Subject: Transmittal of AP1000 Containment Debris Fuel Assembly Testing and RAI Response Summary Presentation (Non-Proprietary)

AP1000 Containment Debris Fuel Assembly Testing and RAI Response  
Summary Presentation (Non-Proprietary)

**Westinghouse Presentation to the NRC Staff  
AP1000 Containment Debris Fuel  
Assembly Testing and RAI  
Response Summary**

- Discuss specific resolutions to recent RAIs that have been submitted
- Demonstrate how the test reports, technical reports, RAI responses, and DCD information submitted to the NRC in January and February 2010 satisfy GSI-191 for AP1000
- Support NRC completion of Chapter 6 SER related to GSI-191 resolution

Table 4-1 AP1000 LTC Sensitivity Analysis With Added Debris Head Losses

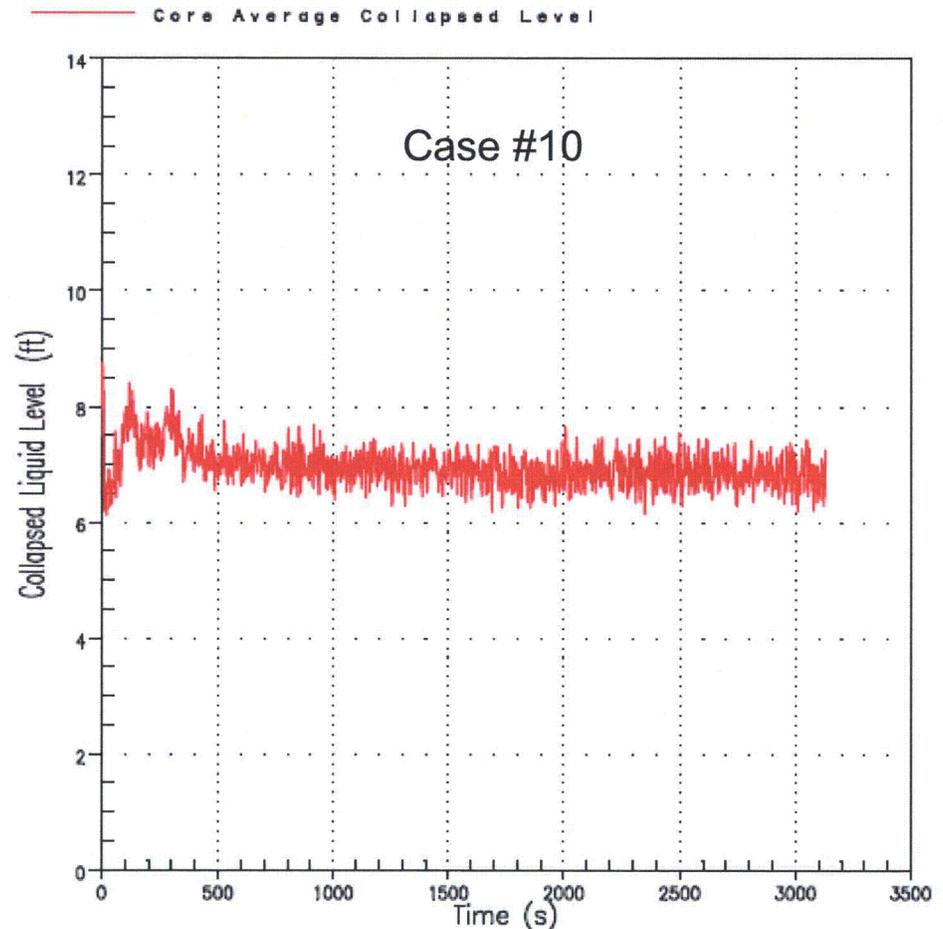
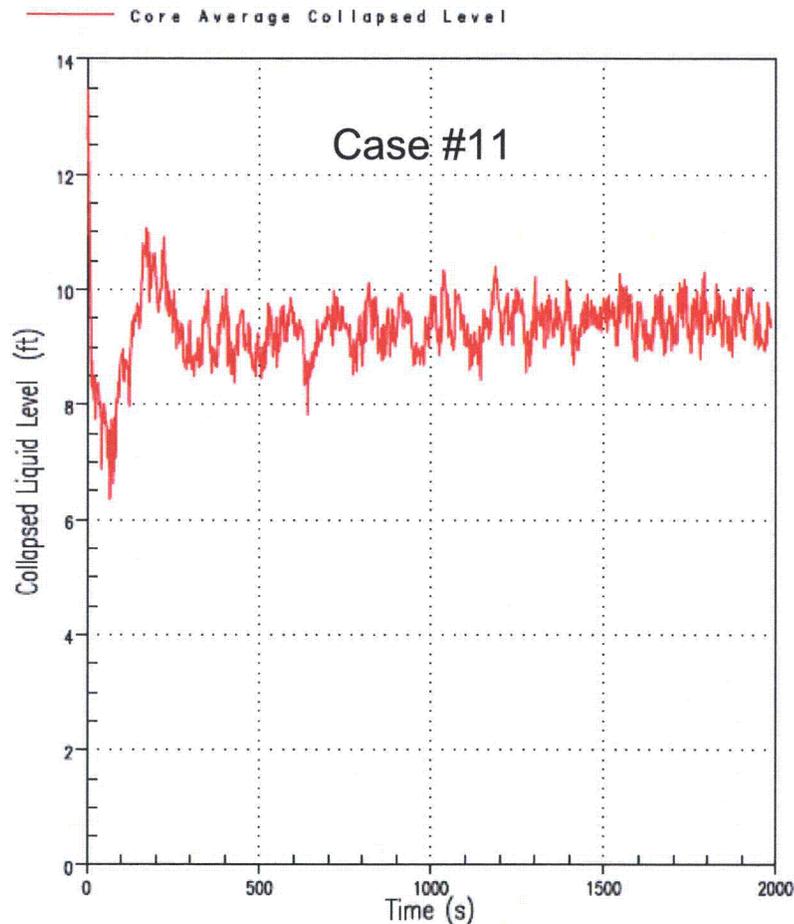
# Case #11

- Similar to Case 10
  - Same time (8.6 hr), break location (DEDVI next to RV), containment conditions, no screen DP
- Difference is that debris resistance moved to core exit
  - Allowable  $K/A^2$  smaller because of impact of steam/water mix on DP (large 2 phase multiplier used)
  - Case allows for debris DP of 2.0 psi at core exit
  - Water flow into core inlet is 214.5 lbm/sec and the ADS 4 vent quality is 10%
  - [
